**Representations on the A66 Northern Trans-Pennine Project**

**Submitted on Behalf of W Austen Richardson Ltd, Mr J Richardson**

**18<sup>th</sup> December 2022**

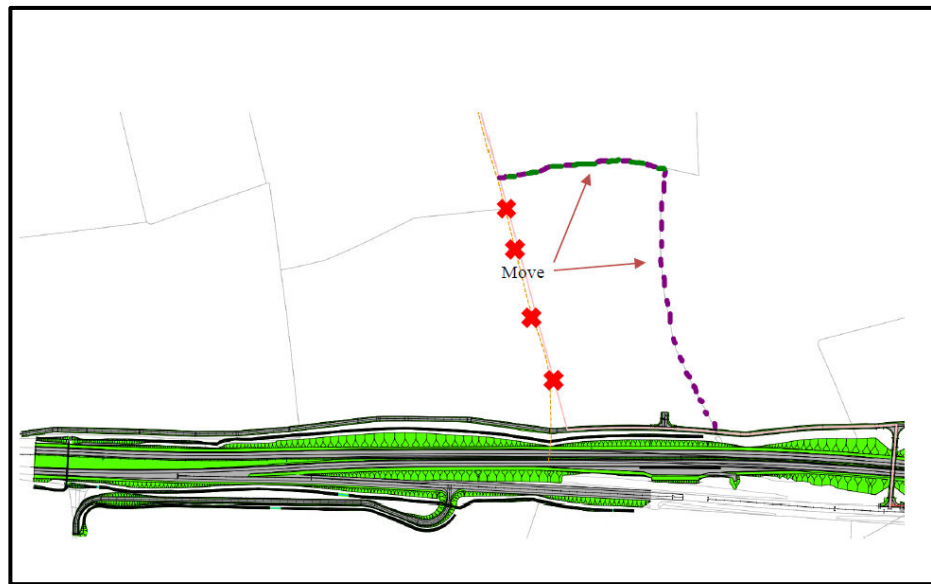
2.4.2 A specific point that we would raise is in relation to a proposed new hedgerow which would serve (environmental benefit aside) no purpose other than splitting a productive agricultural field into two and creating a unfarmable piece of land.

2.4.3 If the hedgerow is required, it would make sense for this to be located further North on the field boundary as the current location of the hedgerow is going across the middle of the field. The plan below shows with the dotted green line the suggested location of the hedge if it is indeed required:

2.7.1 It is anticipated that heavy agricultural machinery will use the access and old A66, so it is therefore suggested that the footpath is moved to follow the field boundary instead of going through the middle of arable fields and close to where machinery will be turning into the tipping area.

2.7.2 The suggested line for the public footpath is shown dotted purple on the plan at 2.4.3 above.
